COUNTRY ESTATES UNIT - 1
PLANNED UNIT DEVELOPMENT
P.U.D. AND ROAD PLAN

JOB NO. 3162-01
DATE JUNE 1993
DESIGNER A.R.C.
CHECKED R.W. DRAWN R.L.
SHEET 1 OF 1

RE: Country Estates Unit-1 Subdivision POADP #381

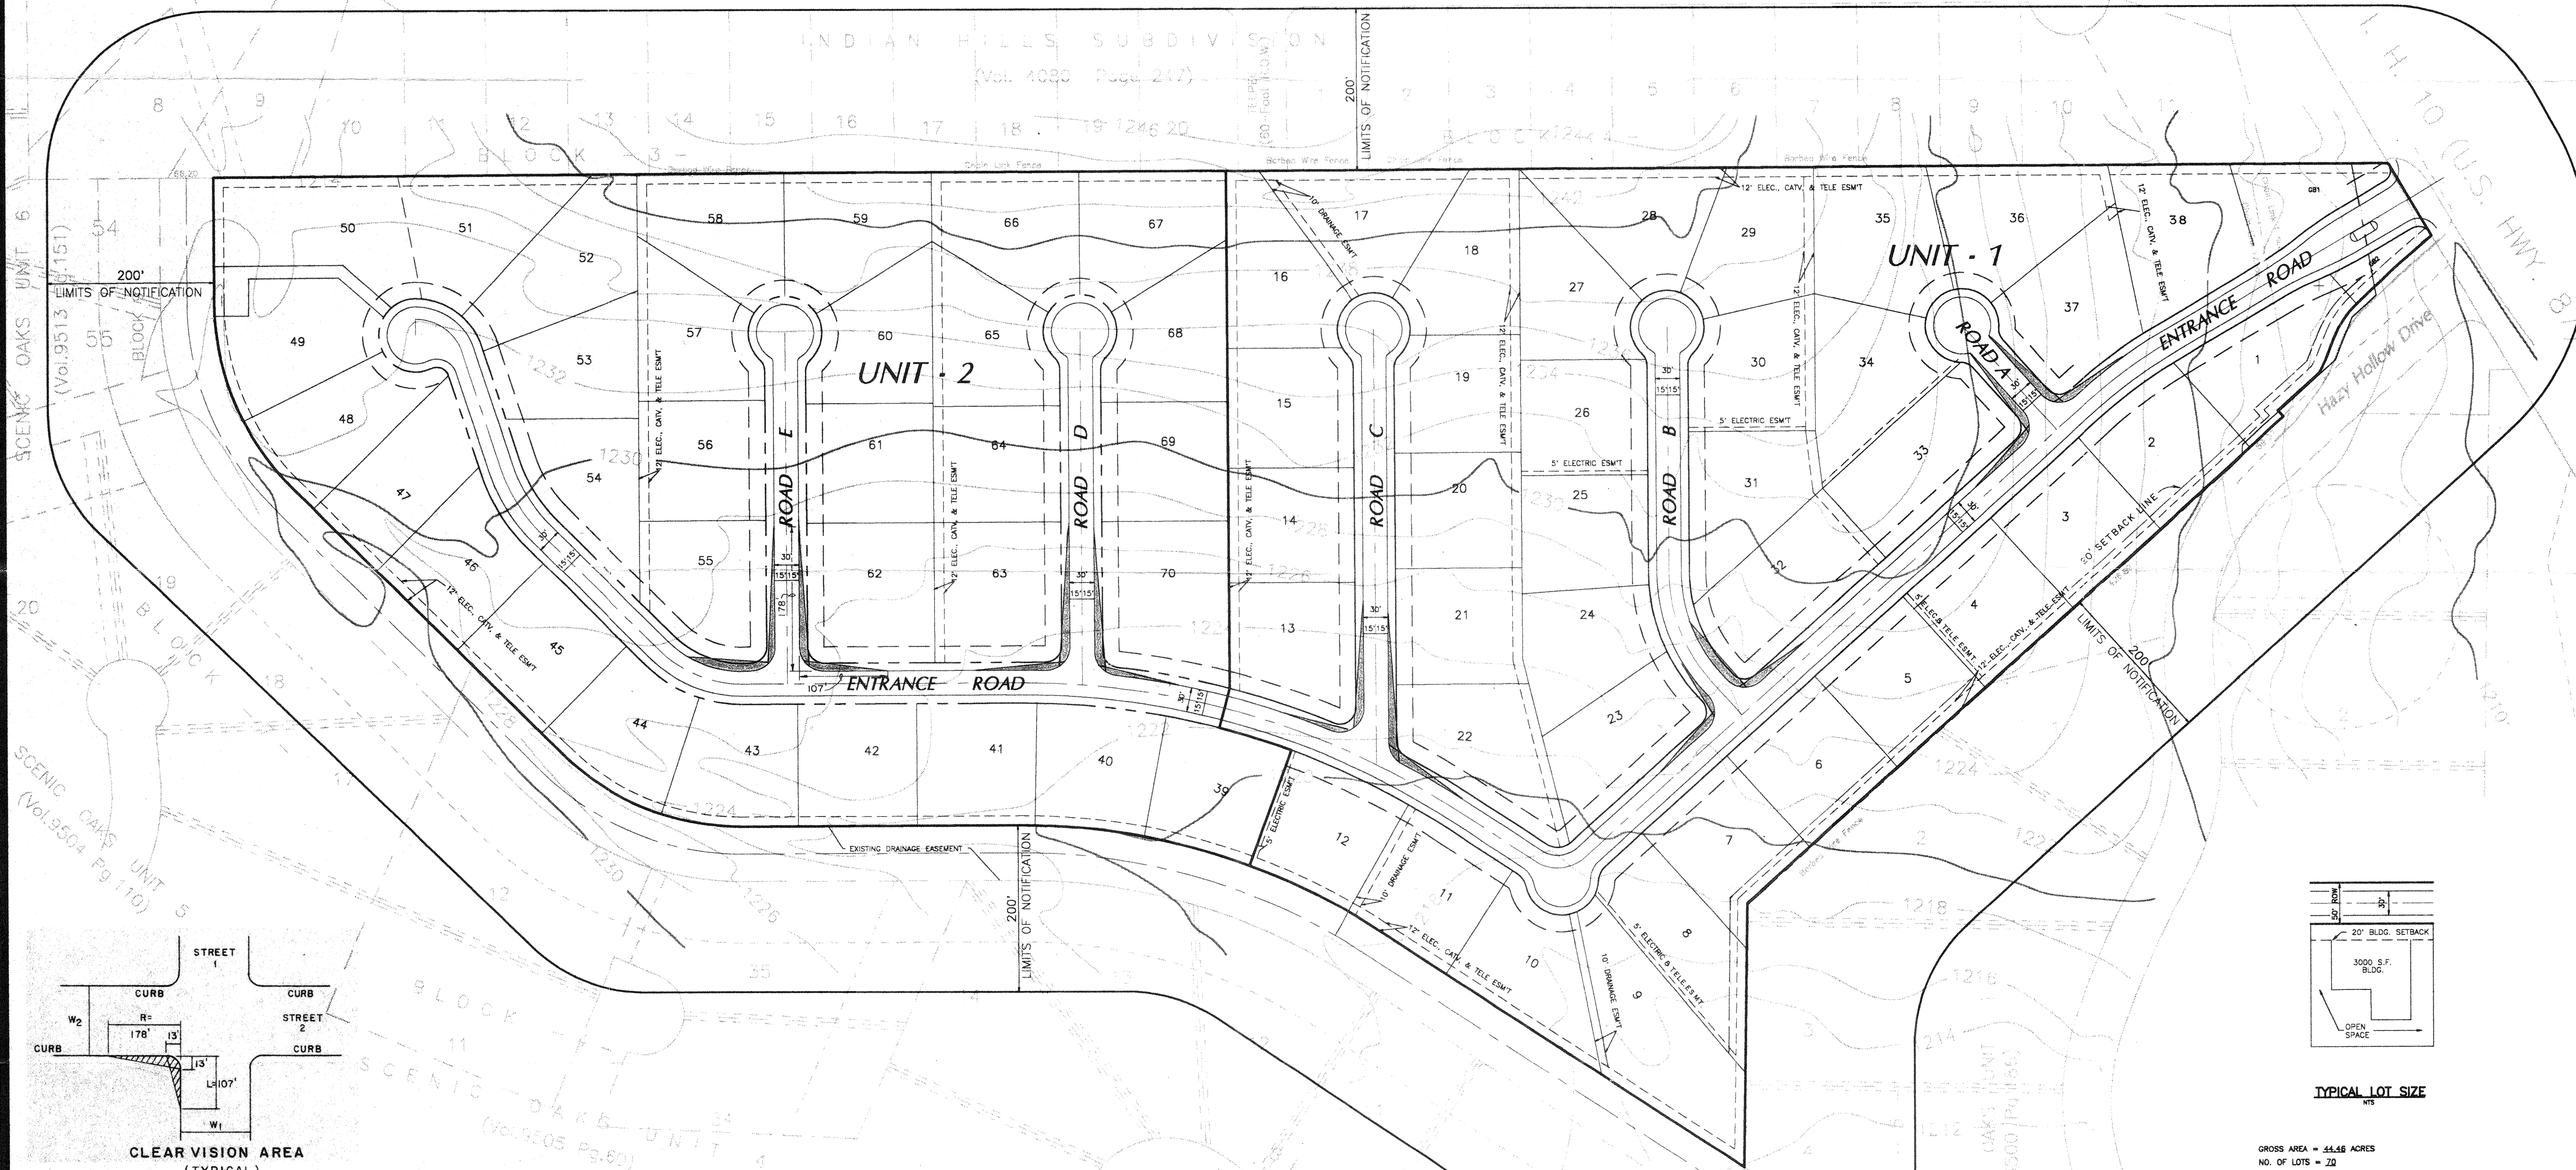
Although your plan was accepted, please note that a variance will be required to section 35-4103, Projection of Streets (extension of Teepee Lane), and section 35-4104, Street Intersections (Hazy Hollow Drive and the entrance road) at the time of plat submittal. It is also suggested that consideration be given to placement of the entrance road off of Hazy Hollow Drive instead of I.H. 10.
